BOA Architecture / Government Services
Rancho Palos Verdes ADA Assessment
Facility Report with Photos

Facility ID: # 02A - City Hall Grounds

Keynote 26

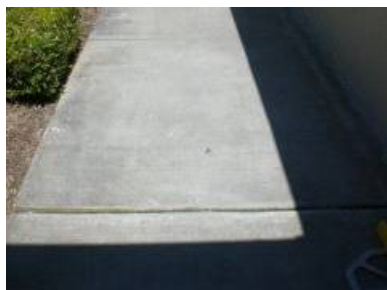
03B.12 - > 1/4" Changes in Level - Where walkway levels change abruptly, the vertical difference between them exceeds 1/4 inch. Or changes in level between 1/4 inch and 1/2 inch are beveled with a slope greater than 1:2.

Keynote 129

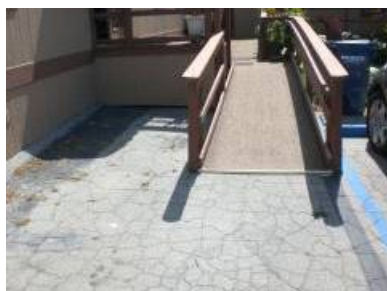
07.11A - Intermediate Landing - Change of Direction - Where there is an intermediate landing, and the ramp changes direction (>30-degree), the landing is less than 72" x 60".
